TECHNICAL EVALUATION REPORT

EVALUATION OF DIESEL GENERATOR FAILURE
AT SHOREHAM UNIT 1

FINAL REPORT, FAILURE CAUSE EVALUATION

NRC DOCKET NO. 50-322

Figure 1. TDI Torsional Stress and Critical Speeds
 [from Reference 14]

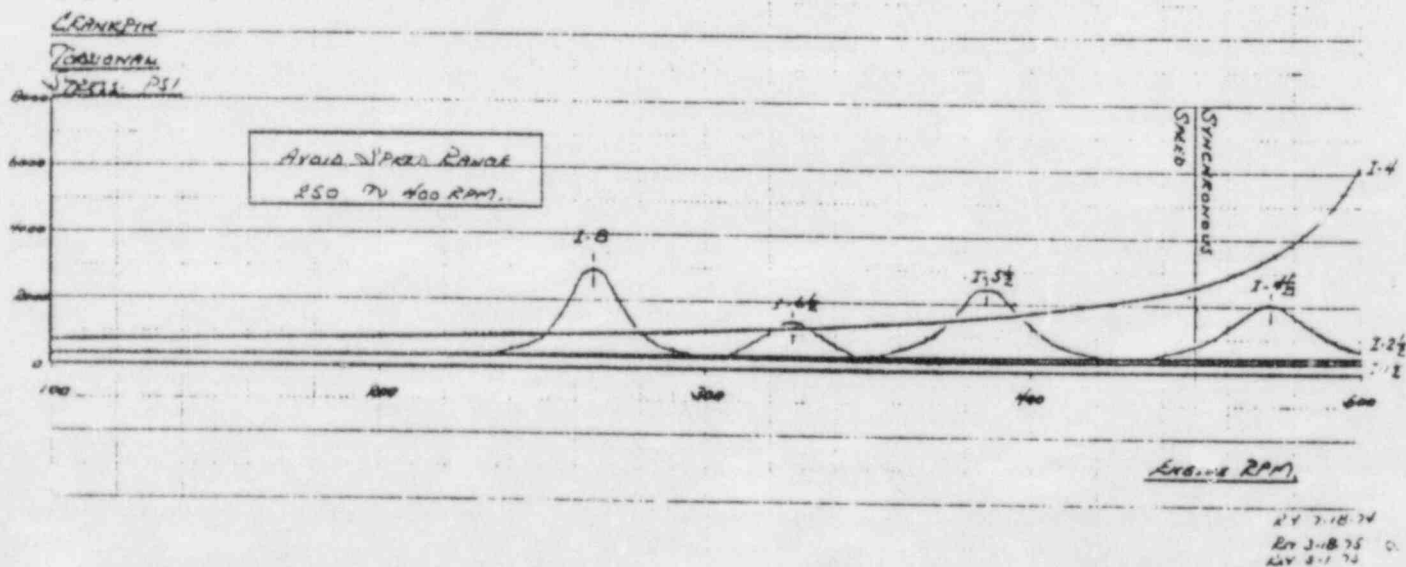
Using its model for the resonant frequencies, TDI calculated the participation of the various orders of known engine excitation and plotted the amplification factors of the more dominant excitation orders as shown in Figure 1, which is a reproduction of the TDI chart from Reference 14. Note that the I-4 (4th order) curve of amplification factor remains the single largest participant, providing more than double the amplitude of the 4 1/2th order during operation at 450 rpm. The excitation frequency of the 4th order is that of 4 times per revolution. This is the firing rate of the cylinders which generates a sharp and dominant excitation. In short, using its analysis, TDI expected to experience a large component of oscillatory torque at 30 Hz (engine firing rate) in the crankshaft. However, a large cyclic torque at 30 Hz is not necessarily bad, provided the associated stress levels

In the course of this review, TDI's use of the T_n values was studied with considerable interest. First, TDI used a different set of T_n values for each of the three mode shapes calculated (Appendix A), but, most significantly, TDI's values are about half the magnitude of the values shown in Table 5 which lists published T_n values. As a consequence, the stress in the crankshaft as calculated by TDI was about half the value calculated from dynamic response analyses employing the published T_n values.

values for diesel engine dynamic response analysis should include all contributions as discussed in Section 4.2.2.2. Because TDI neither described its source for T_n values nor defined the contributors included, it is not possible to discern TDI's technical content. The source and technical justification of TDI's T_n values were requested but have not been provided as of this report. A review of the contributions from sources other than cylinder pressure indicates that the added value is small for the most part, except for the lower orders. For example, piston reciprocating mass provides the largest added value to T_n , -2.845 for the 4th order, 0.0 for the 4.5th order, and +0.408 for the 5th order. These values, added to or subtracted from the historic values, still provide about double the values used by TDI for the critical orders.
